**KNOXVILLE/KNOX COUNTY METROPOLITAN PLANNING COMMISSION  
SUBDIVISION REPORT - CONCEPT/USE ON REVIEW**

▶ **FILE #:** 5-SF-17-C **AGENDA ITEM #:** 13  
5-H-17-UR **AGENDA DATE:** 6/8/2017

▶ **SUBDIVISION:** AUTUMN WALK  
▶ **APPLICANT/DEVELOPER:** B AND B BUILDERS  
OWNER(S): Jason Baker

▶ **PROPOSED USE:** Attached residential development

5-SF-17-C / 5-H-17-UR  
 Revised: 5/19/2017

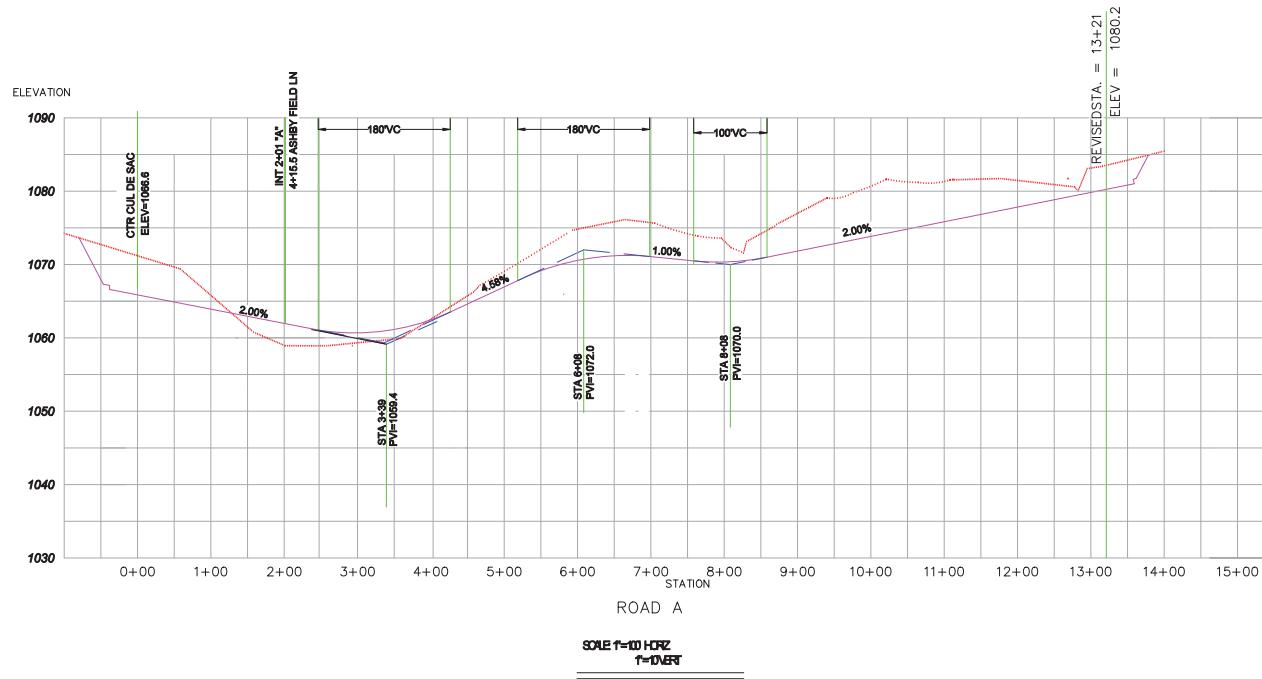
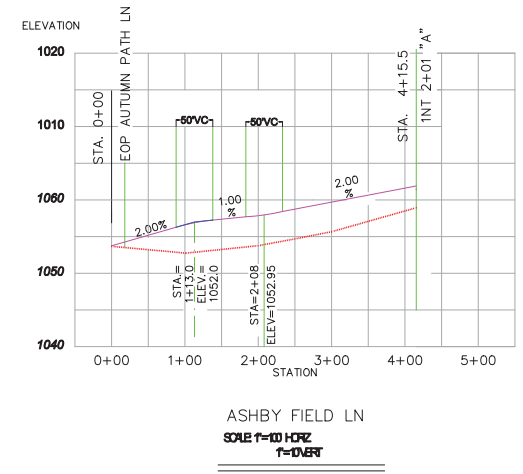
1. Cul-de-sac transition radius both right-of-way and pavement from 75' to 25' at both ends of Road B
2. Broken back curve tangent from 150' to 109.4' between sta. 9+09 and sta. 10+18 of Road B
3. Horizontal curve variance from 250' to 175' at three locations on Road B 1)sta. 6+18, 2)sta. 8+50 and 3)sta. 10+90
4. Horizontal curve variance from 250' to 125' at sta. 0+76 of Road B

3. Installation of sidewalks on at least one side of Ashby Field Ln. and Road B as shown on the concept plan. Sidewalk construction must meet all applicable requirements of the Americans with Disabilities Act (ADA) and shall be installed at the time the street improvements are installed for the subdivision

- ▶ **APPROVE the revised plan for Autumn Walk Subdivision to permit up to 55 additional attached dwellings on individual lots as shown on the concept plan and the reduction of the internal peripheral setback as shown from 35' to 15' subject to 1 condition.**

This new phase of the subdivision will connect to the previously approved portion of the development by the extension of Ashby Field Ln. and tying into Autumn Path Ln. At present, the mail boxes serving the residents of phases 1 and 2 and the associated parking spaces are located in close proximity to where the new intersection will be created. In order to insure traffic safety, the Knox County Department of Engineering and Public Works will require those facilities to be relocated.

- ▶ **APPROVE variances 1 - 4 because site conditions restrict compliance with the Subdivision Regulations, and the proposed variances will not create a traffic hazard.**

**APPROVE the concept plan subject to 12 conditions**
